## **ITEM**

<b>Application Reference</b>	DC/090964
<b>Location:</b>	18-37 High Street Stockport SK1 1EG
<b>PROPOSAL:</b>	Partial demolition/conversion of existing buildings, the creation of a residential development (Use Class C3) comprising 45 units, landscaping, highway works and other associated infrastructure
<b>Type Of Application:</b>	Full
<b>Registration Date:</b>	29/01/24
<b>Expiry Date:</b>	11/07/24
<b>Case Officer:</b>	Chris Smyton
<b>Applicant:</b>	Britannia Stockport Ltd
<b>Agent:</b>	Miss Louisa Fielden, AshtonHale

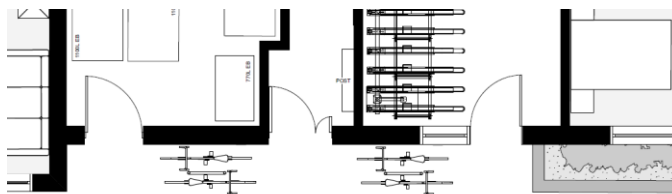
- 1) The proposals relating to the provision of cycle stores in the rear yard area have been further revised, with two 6-space cycle stores proposed to be provided opposite the rear entrance to the converted

block and 3 single-cycle stores located adjacent to Plot 10. Two of the single-cycle stores would be larger stores (measuring 2.6m by 1m) which would enable them to accommodate a wider range of cycles, including many types of non-standard cycle. These three stores, together with the two internal stores (with 12 and 18 spaces) would provide a total of 45 long-stay cycle parking spaces, which is in line with the adopted parking standards.

- 3) The revised scheme still only incorporates a single Sheffield stand for visitors, as opposed to the 2 that were originally proposed. As previously advised and as shown on the drawing below, it would be possible to provide a second stand between the main door to the new block and the door to the cycle store in that block. As such, I consider the provision of 2 visitor cycle stands could be dealt with by condition.

To conclude, I consider the revised proposals generally acceptable. I do, however, consider a second visitor cycle stand should be provided. The provision of this, as well as the need to agree details of the cycle stores can be dealt with by condition. As previously advised, I will provide a list of recommended conditions in due course. As also previously advised, the provision of the disabled parking spaces and loading bay will require the existing Traffic Regulation Order to be amended and the cost of this will

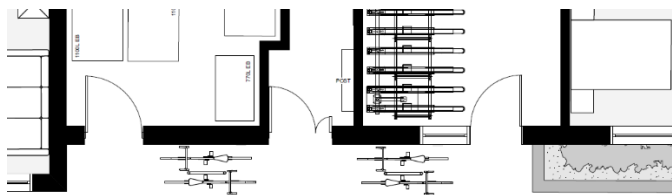
- 8) The revised scheme still only incorporates a single Sheffield stand for visitors, as opposed to the 2 that were originally proposed. As shown on the drawing below, it would be possible to provide a second stand between the main door to the new block and the door to the cycle store in that block. As such, I consider the provision of 2 visitor cycle stands could be dealt with by condition.

To conclude, I consider the proposals to provide external cycle stores and amend the cycle store in the converted building have addressed the key issues I previously raised in respect to cycle parking. I do, however, consider a minor amendment is required to one of the external cycle stores and a second visitor cycle stand should be provided. These matters, as well as the need to agree full details of the cycle parking, however, can be dealt with by condition. As such, I can confirm that I would raise no objection to the revised scheme based on these revised drawings. I will provide a list of recommended conditions in due course. This will include conditions requiring a construction management plan, provision of cycle parking, footway reconstruction and accessibility improvements, the implementation of travel plan measures and works to amend the highway abutting the site so as to provide disabled parking spaces and a servicing layby. As previously advised, the provision of the disabled parking spaces and loading bay will require the existing Traffic Regulation Order to be amended and the cost of this will need to be funded by the applicant (collected via a S106 Agreement) and I would also recommend that the S106 agreement includes a clawback which requires the applicant to fund EV charging points in the vicinity of the site in the event that the viability of the scheme changes.

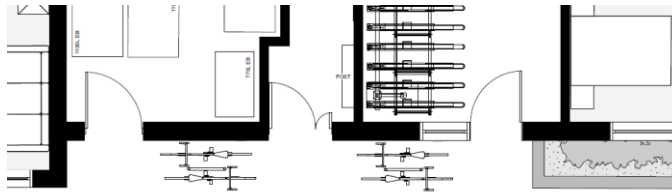
- 5) The revised scheme still only incorporates a single Sheffield stand for visitors, as opposed to the 2 that were originally proposed. As shown on the drawing below, it would be possible to provide a second stand between the main door to the new block and the door to the cycle store in that block. As such, I consider the provision of 2 visitor cycle stands could be dealt with by condition.

To conclude, I consider the proposals to provide external cycle stores and amend the cycle store in the converted building have addressed the key issues I previously raised in respect to cycle parking. I do, however, consider a minor amendment is required to one of the external cycle stores and a second visitor cycle stand should be provided. These matters, as well as the need to agree full details of the cycle parking, however, can be dealt with by condition. As such, I can confirm that I would raise no objection to the revised scheme based on these revised drawings. I will provide a list of recommended conditions in due course. This will include conditions requiring a construction management plan, provision of cycle parking, footway reconstruction and accessibility improvements, the implementation of travel plan measures and works to amend the highway abutting the site so as to provide disabled parking spaces and a servicing layby. As previously advised, the provision of the disabled parking spaces and loading bay will require the existing Traffic Regulation Order to be amended and the cost of this will need to be funded by the applicant (collected via a S106 Agreement) and I would also recommend that the S106 agreement includes a clawback which requires the applicant to fund EV charging points in the vicinity of the site in the event that the viability of the scheme changes.
